PLAN COMMISSION MEETING AGENDA

**TUESDAY, June 28, 2016
AT 6:00 PM**

Plan Commission Report

PROJECT: Plan Review – Howell Development Phase II (Pamela Mehta)

EXHIBIT A: CONCEPT SITE PLAN

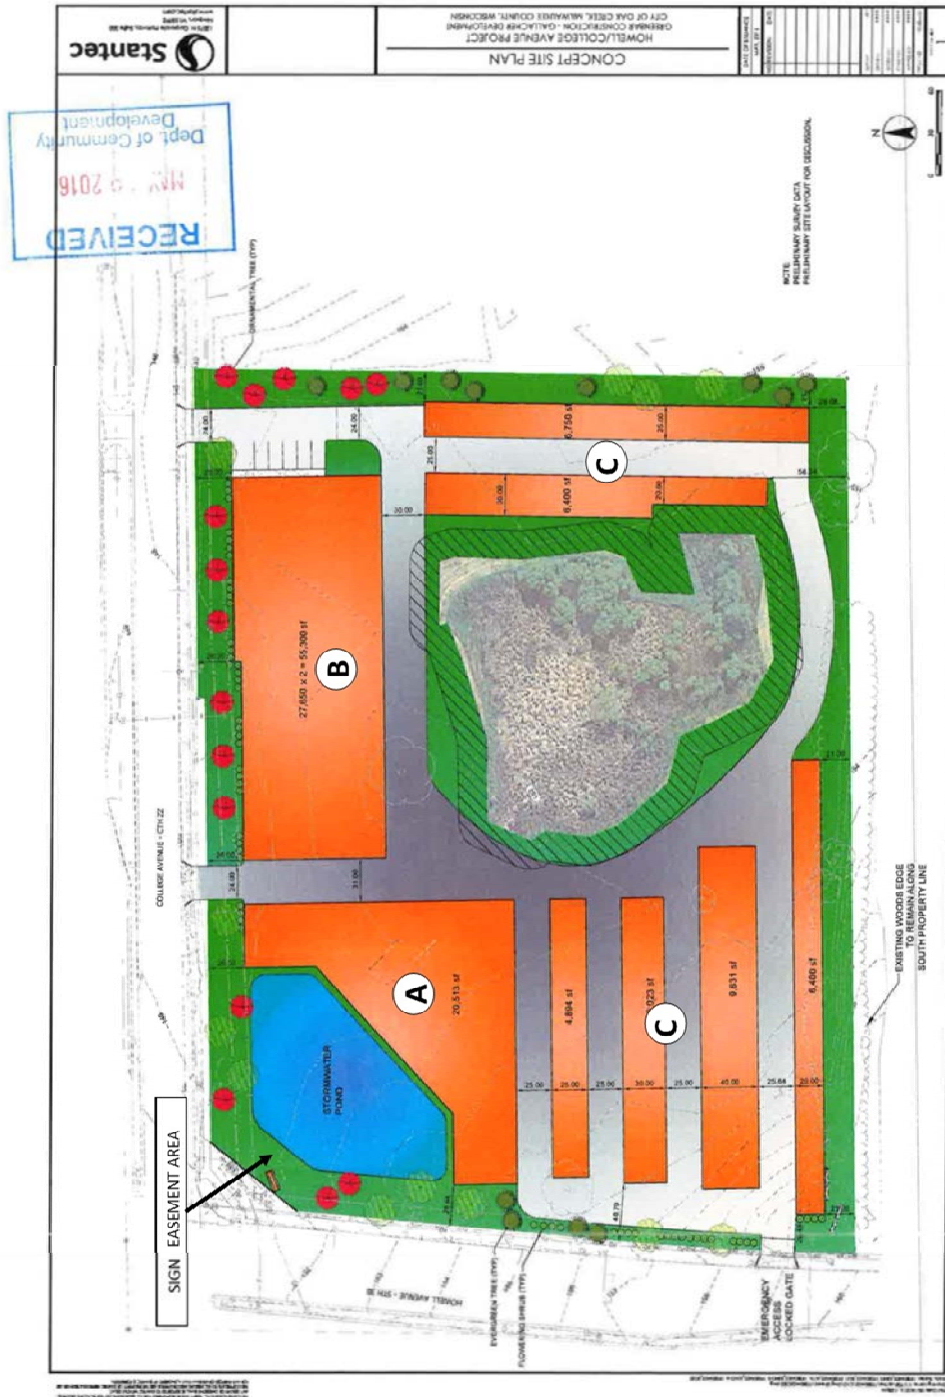
- B. Building permits must be issued to both buildings "A" and "B" (as illustrated in Exhibit A – Concept Site Plan) prior to the issuance of building permits for any other storage structures (Building type "C").

- C. Occupancy permits must be obtained for Buildings "A" and "B" (as illustrated in Exhibit A – Concept Site Plan) prior to the issuance of occupancy permits for any other storage structures (Building type "C").

SITE PLAN

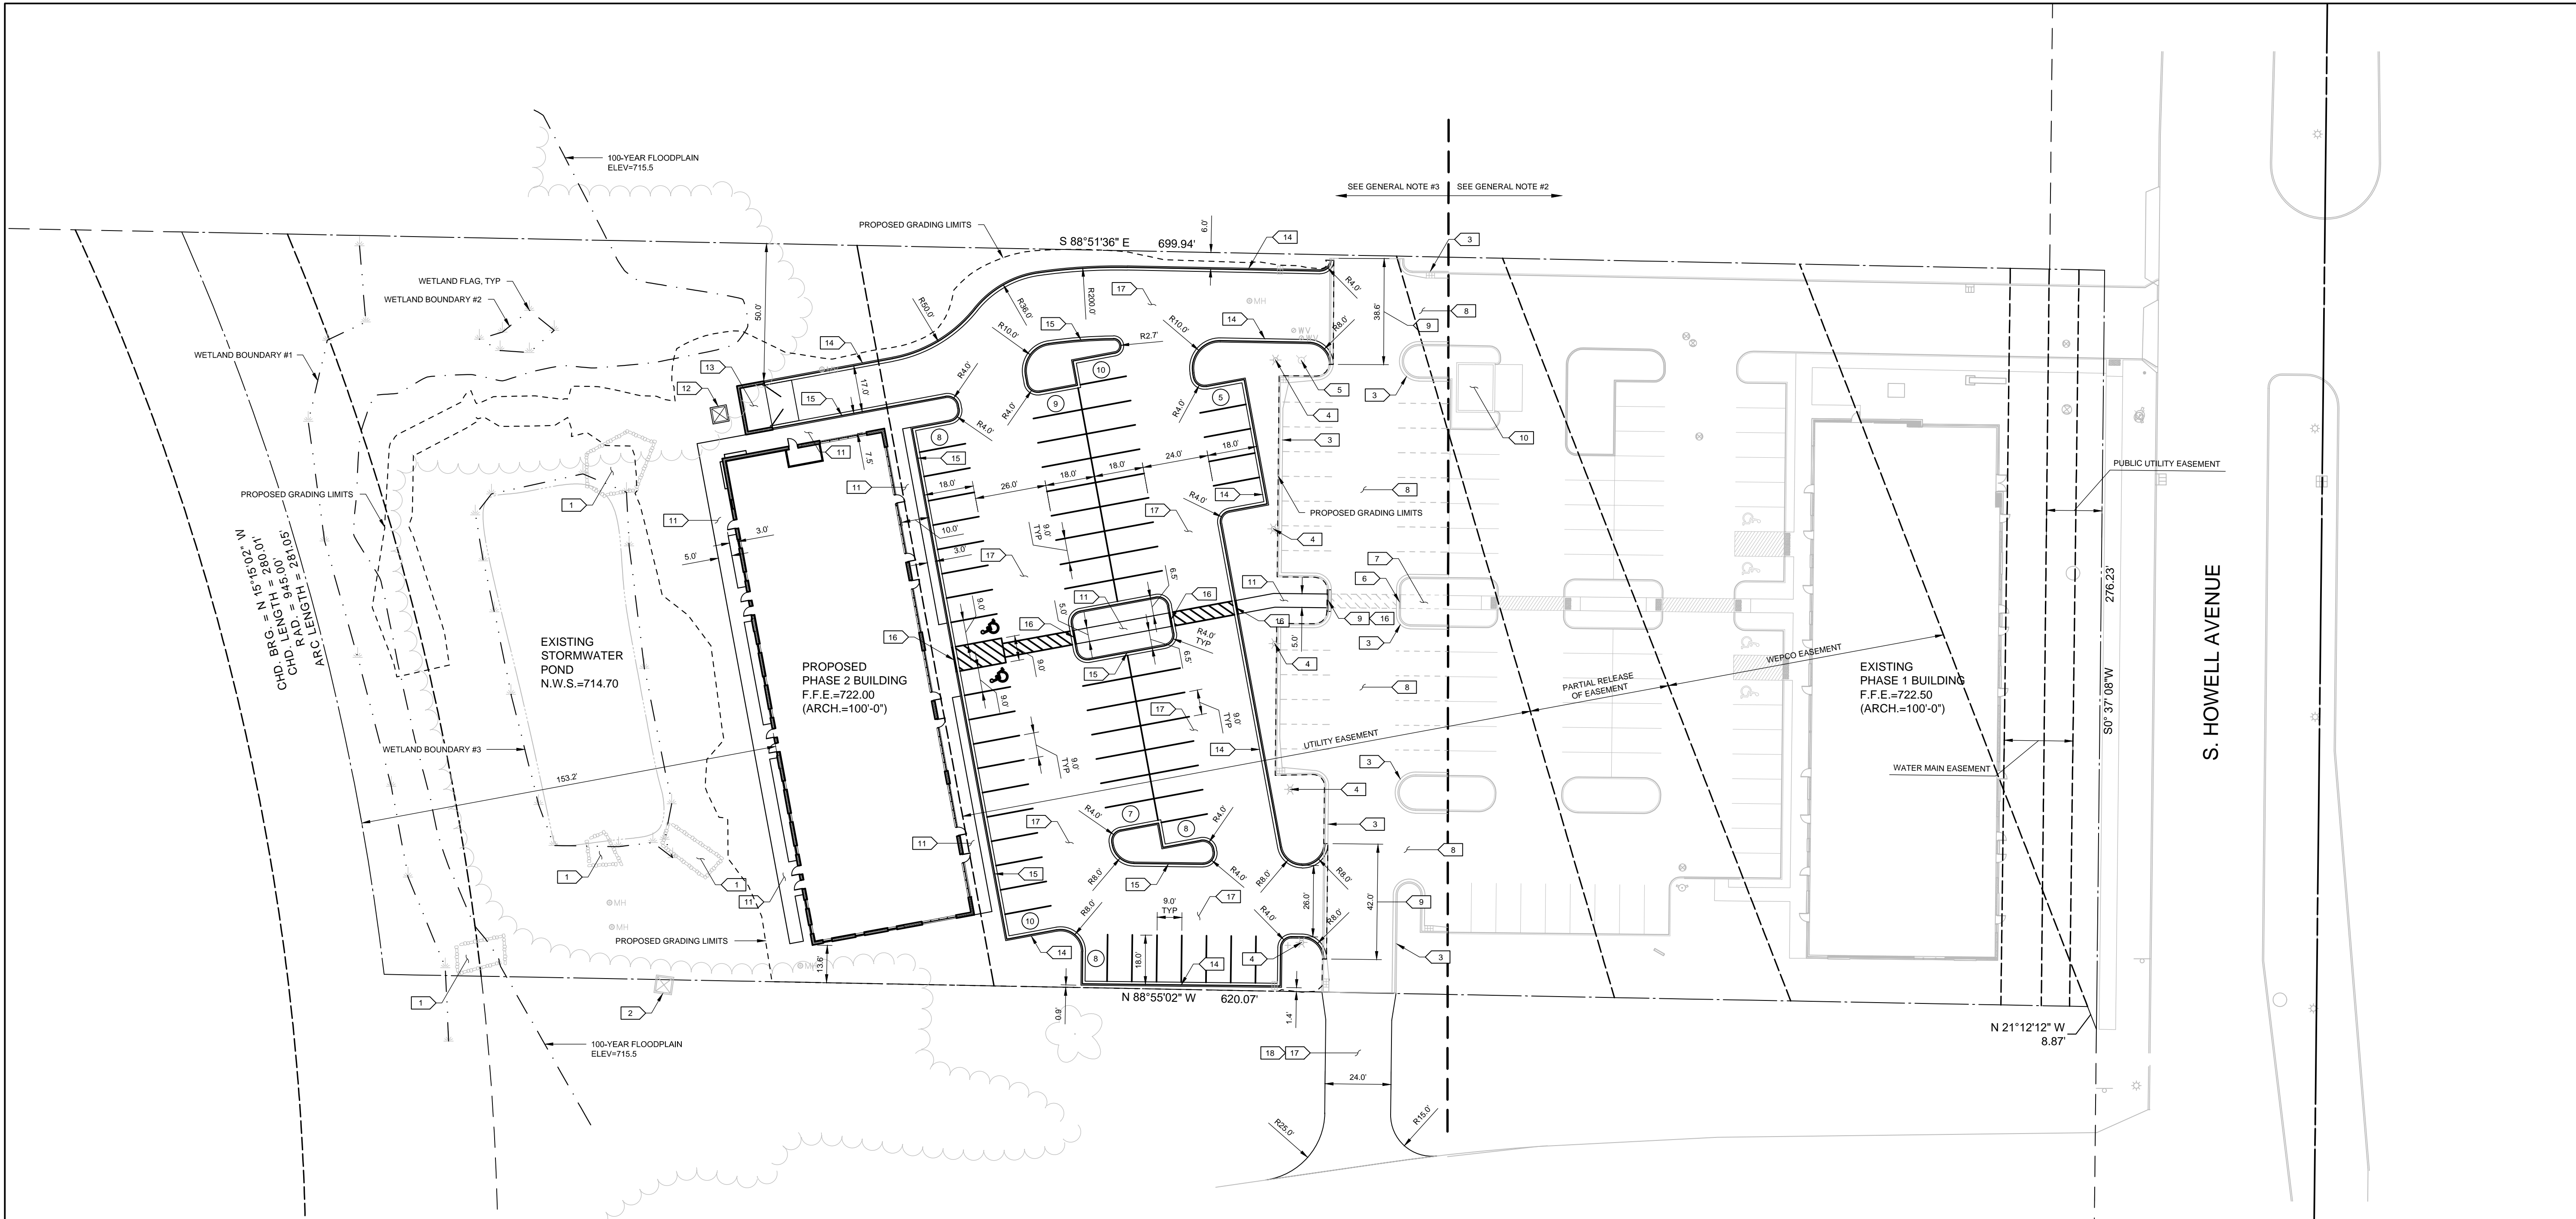
The Phase 2 building will be a one-story, multi-tenant building, and will be 10,800 square-feet in area. It is anticipated to accommodate up to seven tenants. The purpose for the angled building orientation is to not locate the building within the American Transmission Company's easement as identified on the site plan. The building meets all setback requirements for the zoning district.

Parking will be located in between the two buildings, providing a total of 158 parking spaces. This development will provide an additional 67 parking stalls. Since building one consists mainly of personal service and medical offices, it is anticipated similar uses will occur in building two. Because of the anticipated uses, the demand for parking is less than what City Code would require. Included in this report is a parking analysis explaining why there is only a need for 158 spaces for the two buildings. To accommodate landscaping along the south lot line the applicant will likely need to reduce parking by an additional three spaces. If the Plan Commission is satisfied with the explanation for the reduced amount of parking, the Plan Commission has the authority to approve the proposed number of parking stalls.

1 PROPOSED PHASE II LANDSCAPE PLAN

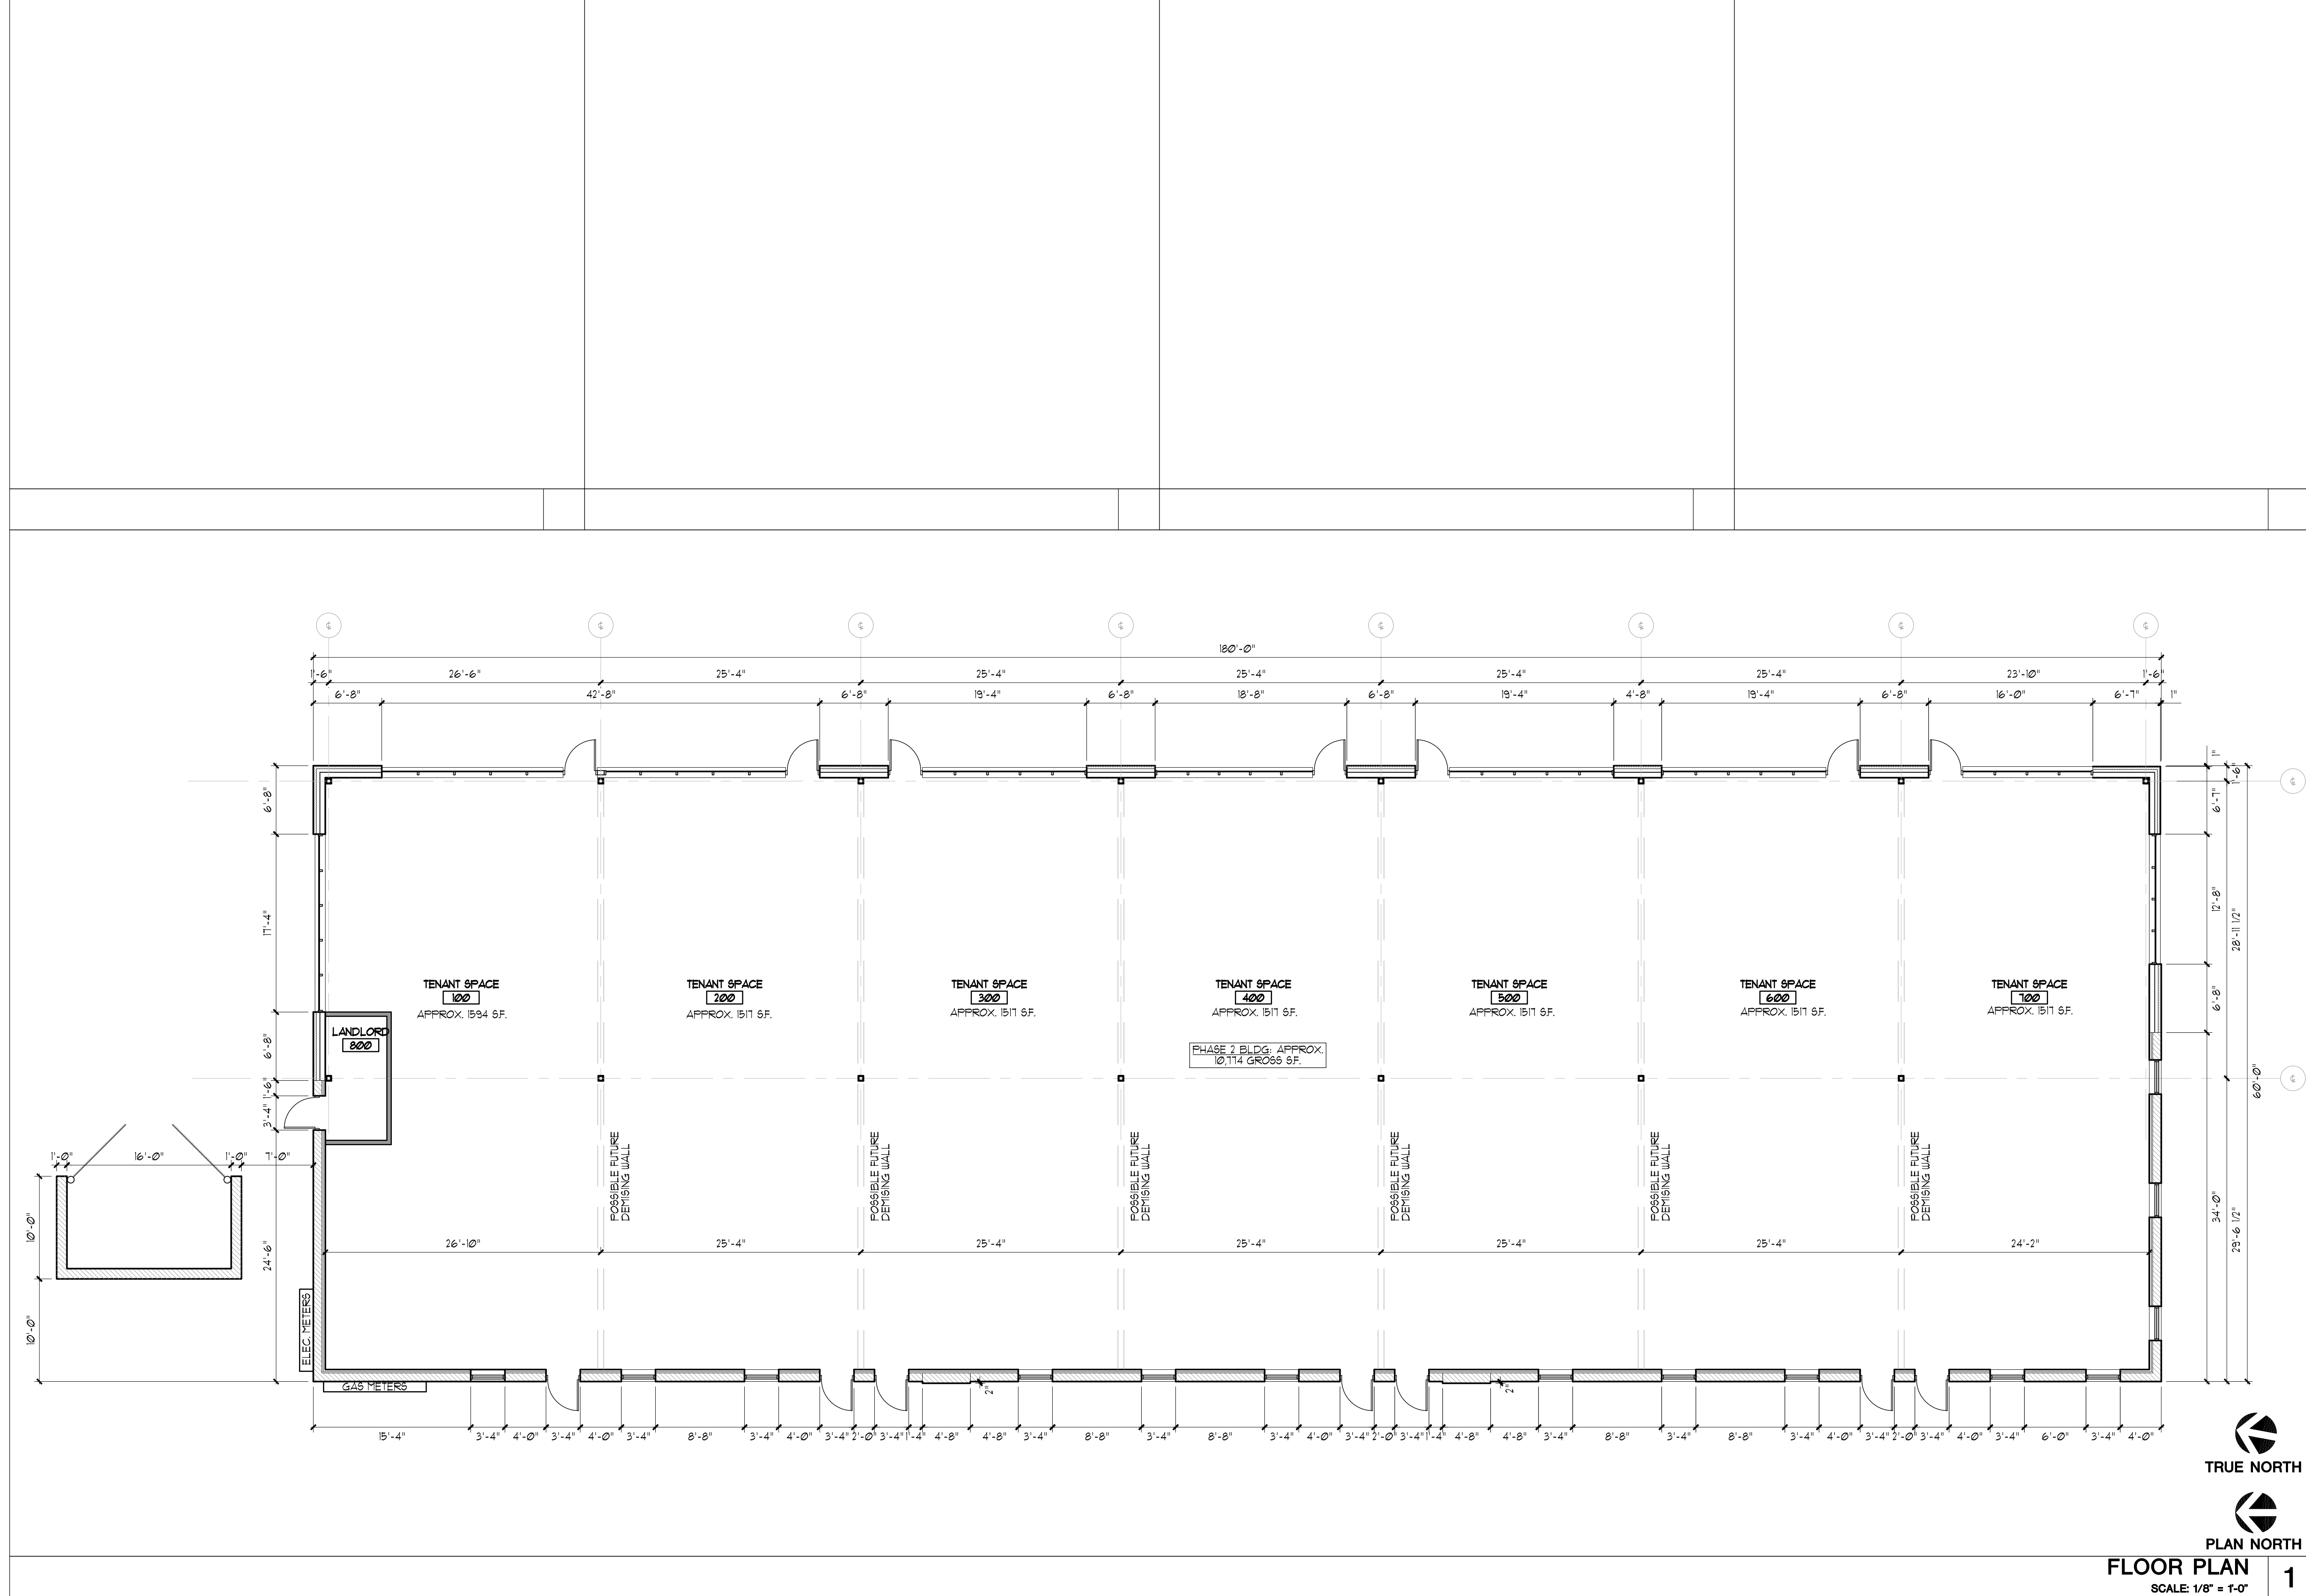
The proposed landscaping plan meets minimum requirements except for the south lot line and interior parking islands. To accommodate the south lot line, the applicant will need to modify the parking lot to create the five-foot setback and modify the landscape plan to show landscaping along the south lot line. Interior parking islands do not include trees as required by code since there exists an American Transmission Company easement which restricts the height of any structure to twenty feet. The proposed landscaping is similar to what was approved in Phase 1. The Plan Commission can approve of the modification with a ¾ approval.
